Service Bulletin No. 398B

<i>MODEL</i>	D Series	<i>TYPE</i>	Field Change Program	<i>SECTION/GROUP</i>	7 – Electrical	<i>DATE</i>	Aug. 15, 2013
<i>SUBJECT</i>	ACTIA POWER MANAGEMENT MODULE 1 / OUTPUT 29						
<i>CONDITIONS</i>

Figure 4.

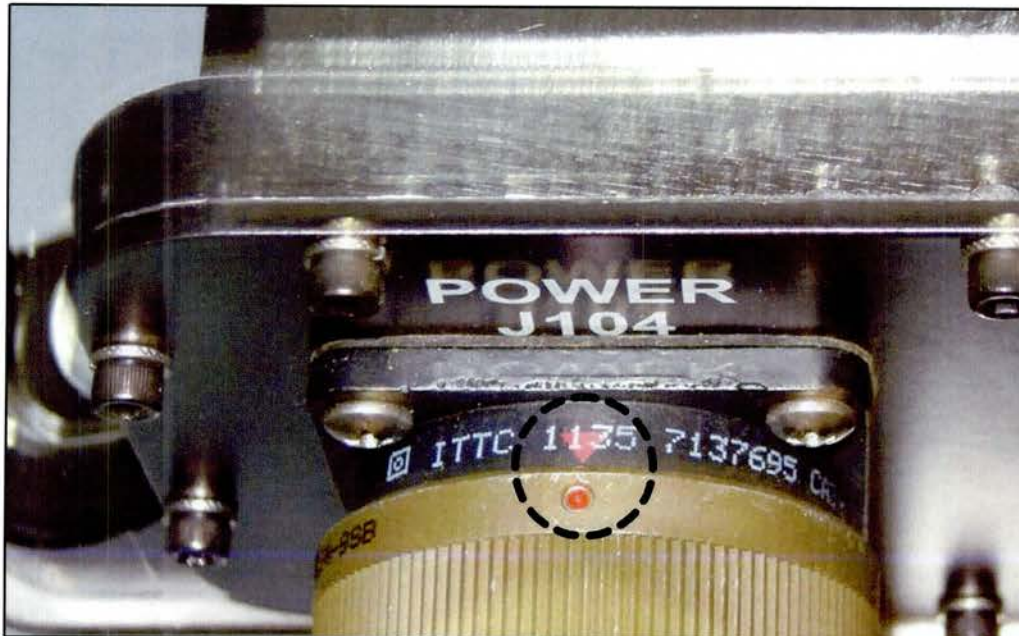
- Disconnect all four (4) connectors from the PMM.
- Remove and retain the mounting hardware. Remove the module and retain, to be submitted with claim.
- Using existing hardware, install the new module, p/n 07-08-4992 or later. Torque to 19 ft-lbs.
- Hand tighten the mating plug to PMM J104. For proper installation, ensure that the red dot and the arrow are aligned (refer to Figure 4).

Figure 5.

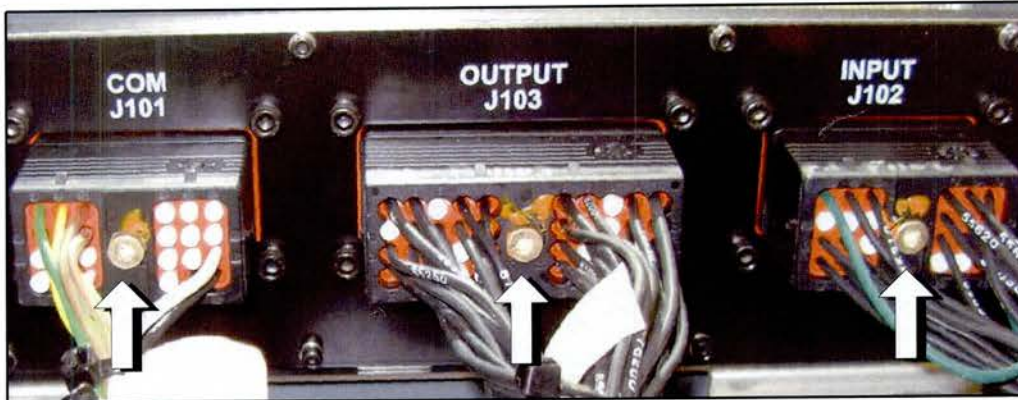
11. Orient and connect connectors PMM J101, J103 and J102. Using a 4 mm or 5/32 hex wrench, torque the connector bolts to 25 in-lbs (refer to Figure 5).
